**WHITE LAKE TOWNSHIP
INTER-OFFICE MEMORANDUM
COMMUNITY DEVELOPMENT DEPARTMENT**

**SUBJECT: Comfort Care White Lake
Rezoning request and preliminary site plan approval**
Property described as parcel number 12-36-176-002, located on the west side of Union Lake Road, between Hutchins Road and Cooley Lake Road, consisting of approximately 8.7 acres. Applicant requests to rezone the property from (LB) Local Business to (PD) Planned Development or any other appropriate zoning district.

RE: Comfort Care Assisted Living- Preliminary Site Plan Review – 4th Review

RE: Comfort Care
Rezoning and Preliminary Site Plan – Review #4

PROJECT NUMBER	210303	SHEET
PROJECT PHASE	SPA	C200

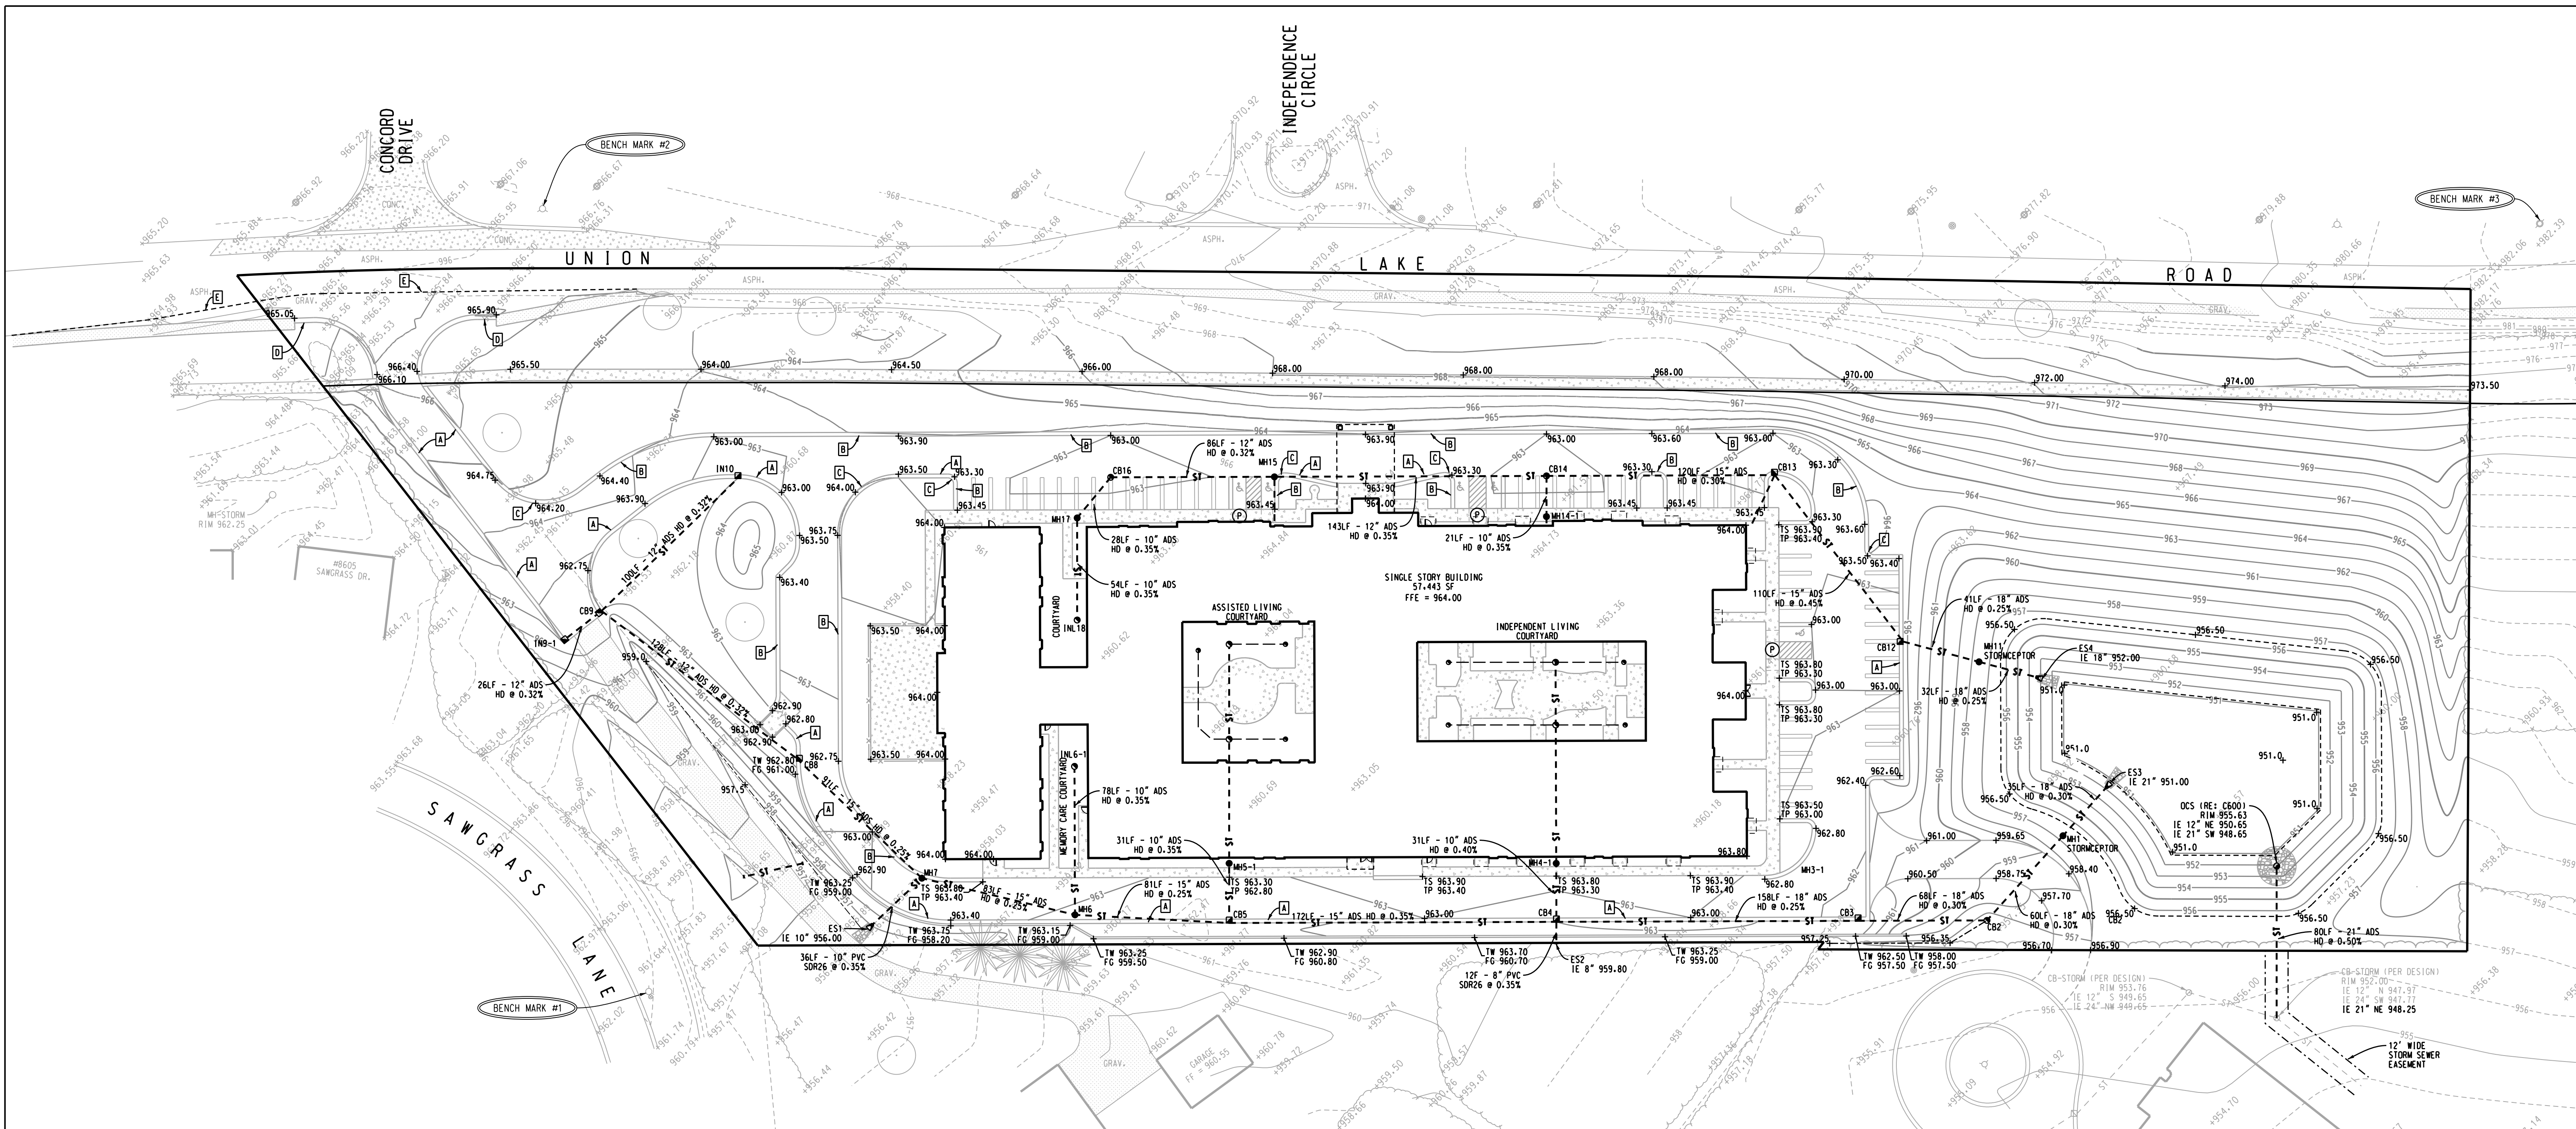
An updated list of all requested waivers shall be provided on Sheet C200 of the site plan.

PROJECT NUMBER	210303	SHEET	C400
PROJECT PHASE	SPA

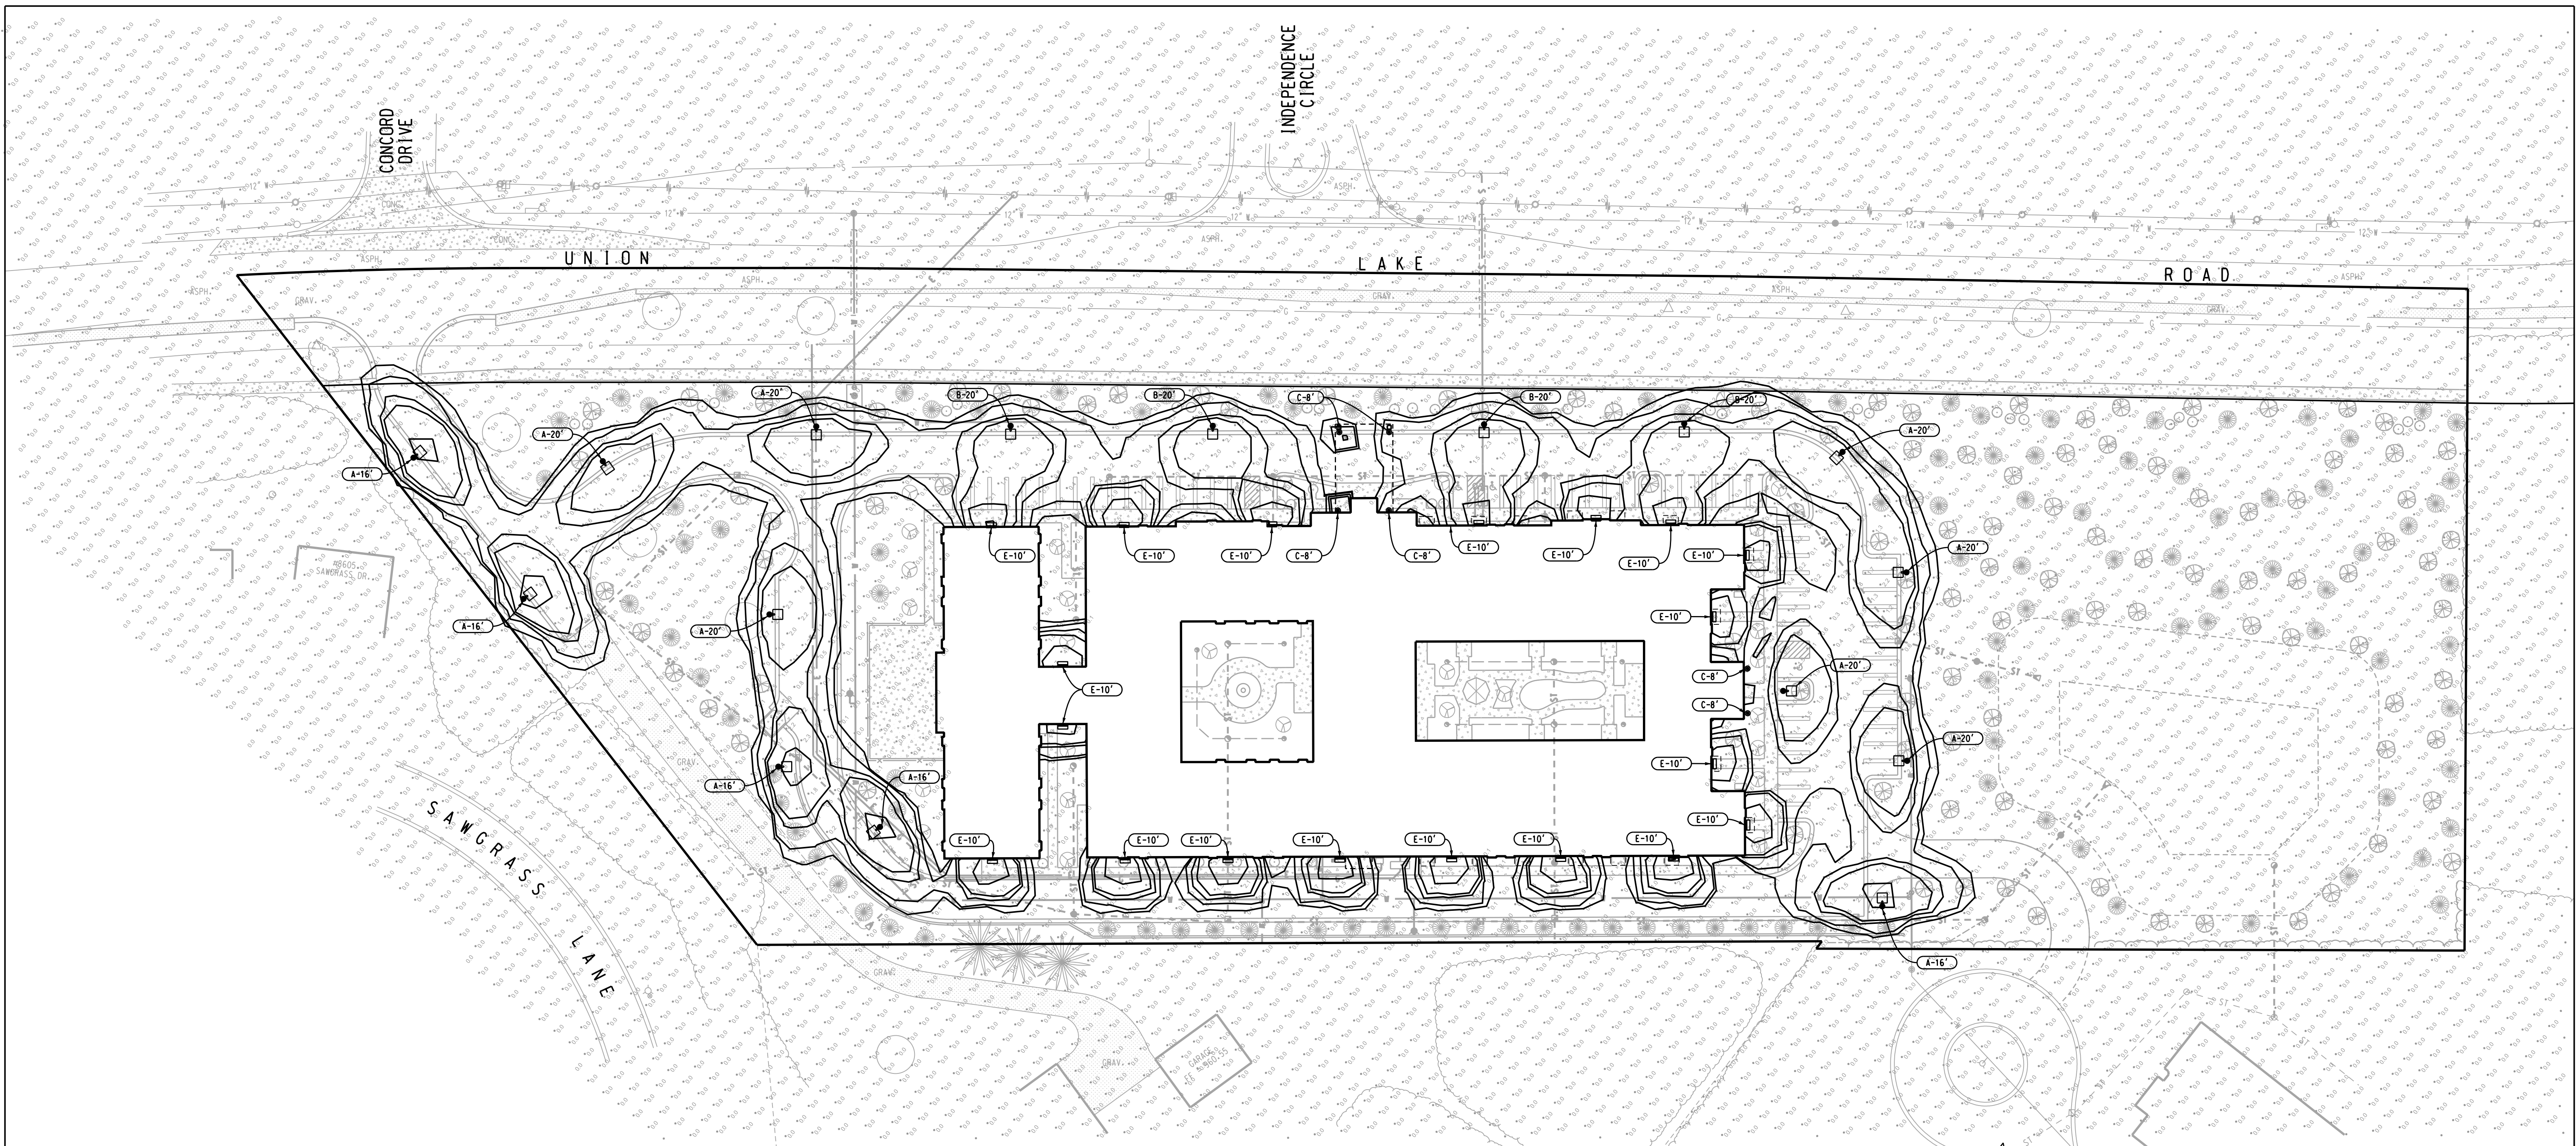
1. *We defer to the Fire Department regarding items related to fire suppression and hydrant coverage. **Comment remains as a notation.***
 2. *Remove all references to Genessee County on the water main notes on Sheet C400- Site Utility Plan. Note that all notes regarding proposed utilities shall be per White Lake Township standards. **Comment addressed.***
-

PROJECT NUMBER	210303	SHEET	C500
PROJECT PHASE	SPA

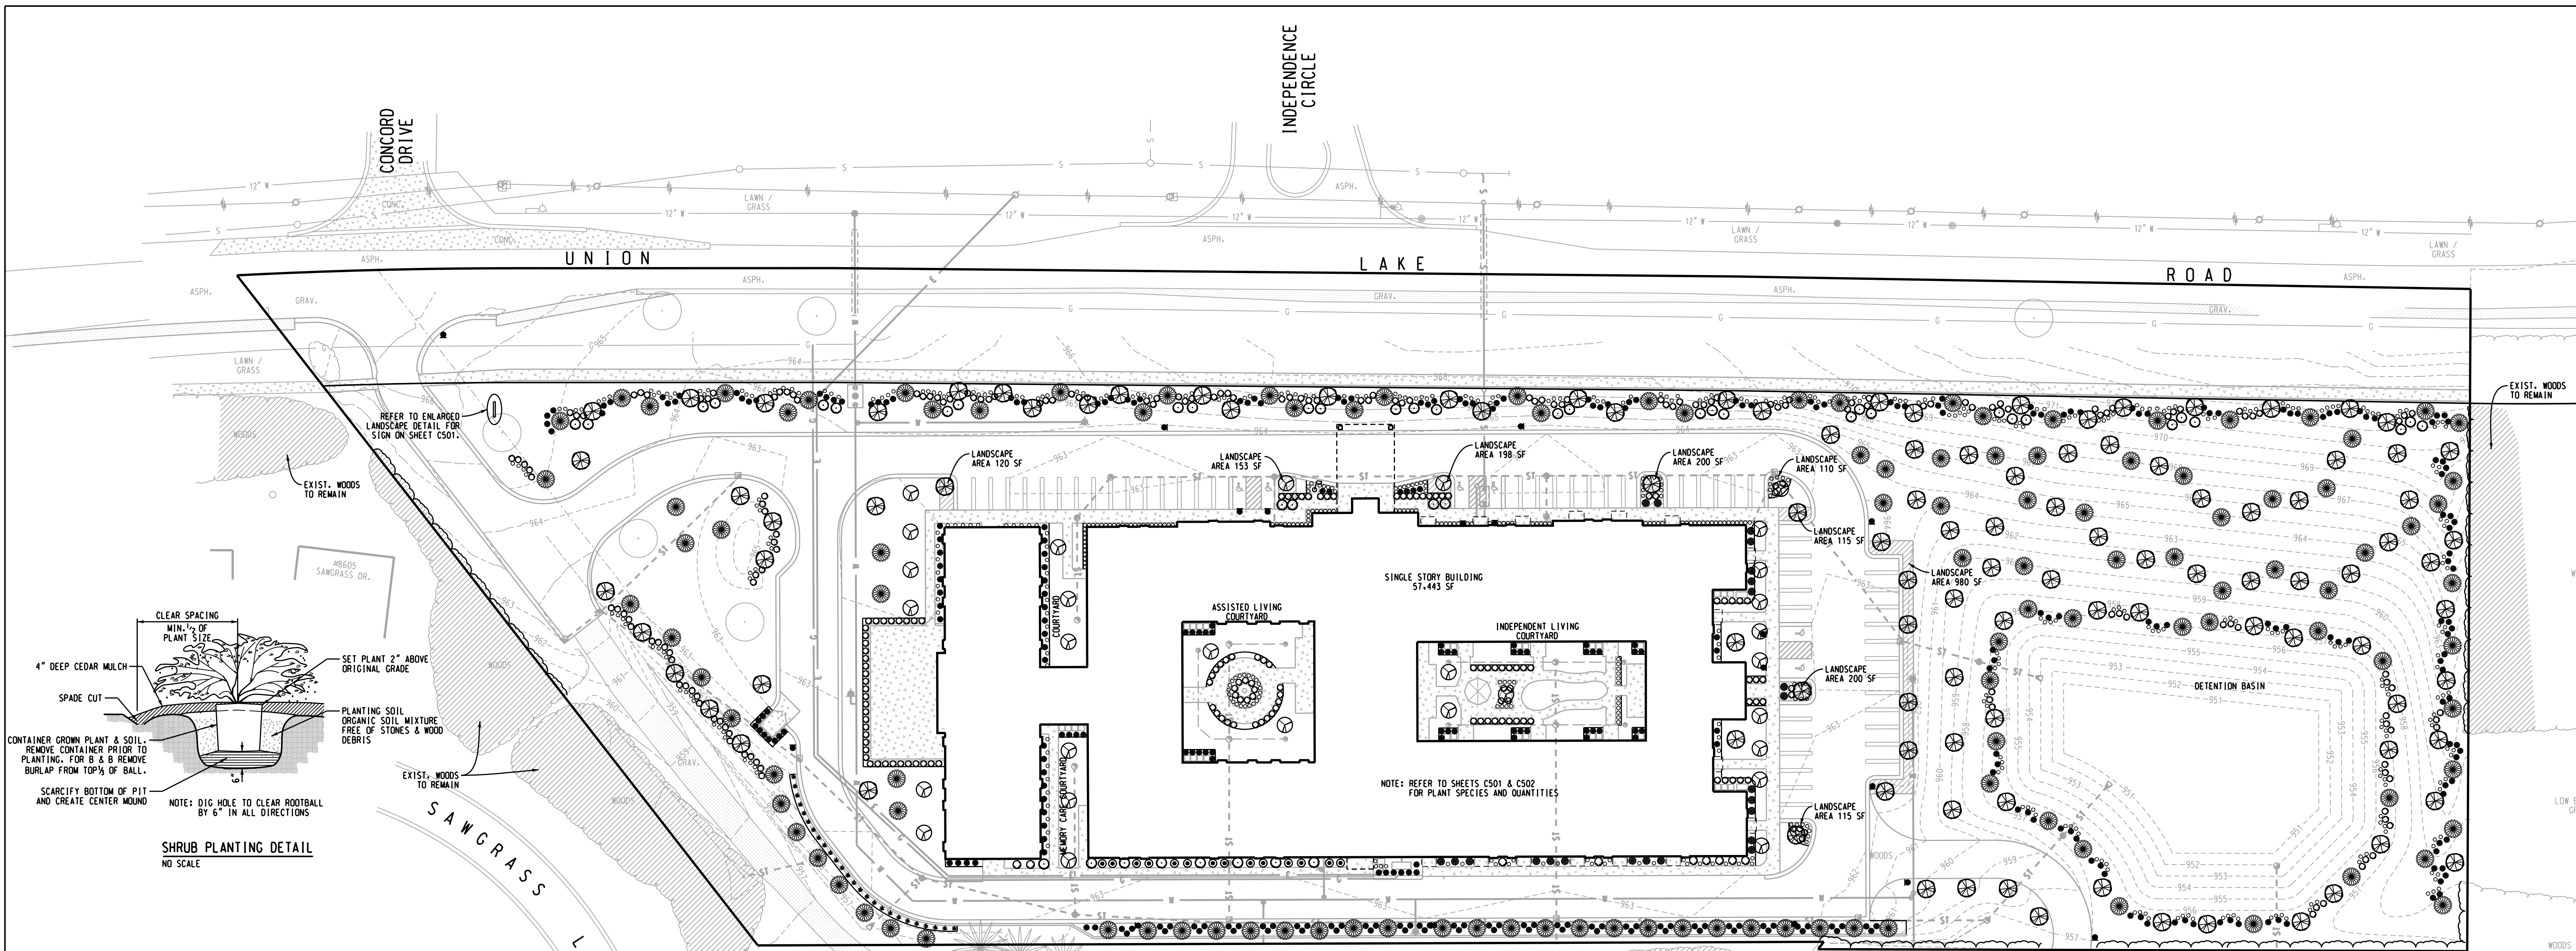
- The 980 square foot landscape area is not considered parking lot landscaping and shall be removed from said calculation. **Revise accordingly.**
- Trees shall not be planted closer than four feet to a property line. **Add note to landscape plan at final site plan.**

- Note 9 on the landscape plan mentions mulch. Sheet C500 also contains a mulch and edging detail. The zoning ordinance states the mulch product itself shall be at least doubled-shredded quality. **Revise accordingly.**

- The Planting Requirements table on Sheet C500 shall be revised to indicate the screen wall requirements for the 'Residential Buffer (west side)' minimum requirement.
